M25 junction 28 improvement scheme

TR010029

9.104 Applicant's comments on Grove Farm's Deadline 6 submission

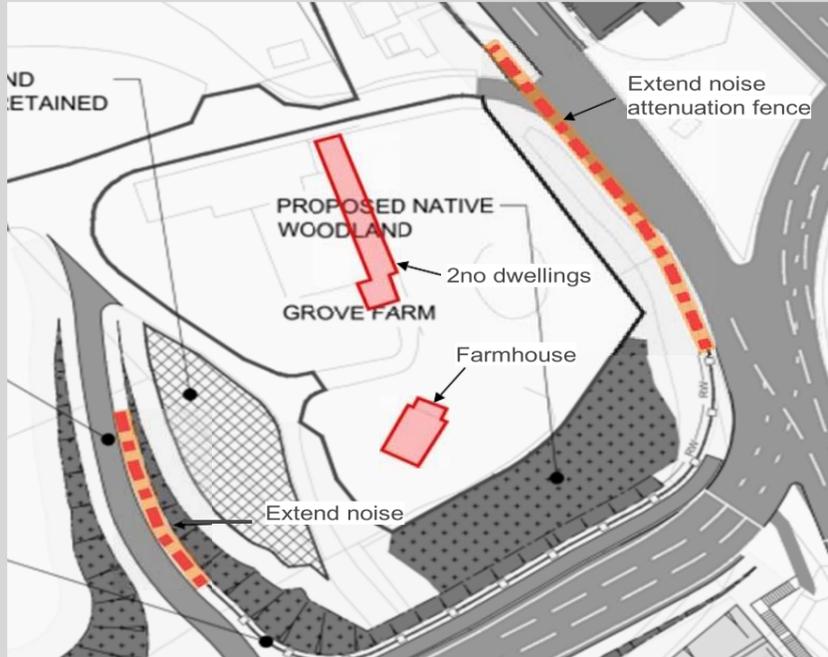
REP6-041-17	<p>v) The re-alignment of the A12 eastbound on-slip will relocate traffic flows closer to existing dwellings. A noise attenuation barrier should be extended into the site at the site egress as shown on Fig 3.2:</p> <p>Figure 3.2 – Grove Farm’s suggested location for extra noise attenuation fencing</p> 	<p>Highways England have estimated the performance of a 2m noise barrier along the A12 Eastbound off-slip around to the Grove Farm entrance. A noise barrier in this position would change the overall noise levels at Grove Farm by less than half a decibel. The noise levels at Grove Farm are dominated by the traffic on the M25 carriageway, which would not be screened by a barrier in this location. The overall impact of the Scheme would remain negligible if a noise barrier were to be constructed in this location.</p> <p>If a barrier were to be erected in this location, extending it along the Grove Farm egress would make no difference to the results because the extension to the barrier would not interrupt the line of sight between Grove Farm farmhouse and the A12 slip road.</p> <p>If a barrier were to be erected in this location, extending it along the M25 slip road would make a small difference to the results at Grove Farm, because the mainline M25 carriageway remains elevated above the junction. Highways England would expect that changes in noise as a result of the Scheme would remain negligible with any of the barrier options suggested by the representatives of Grove Farm.</p>
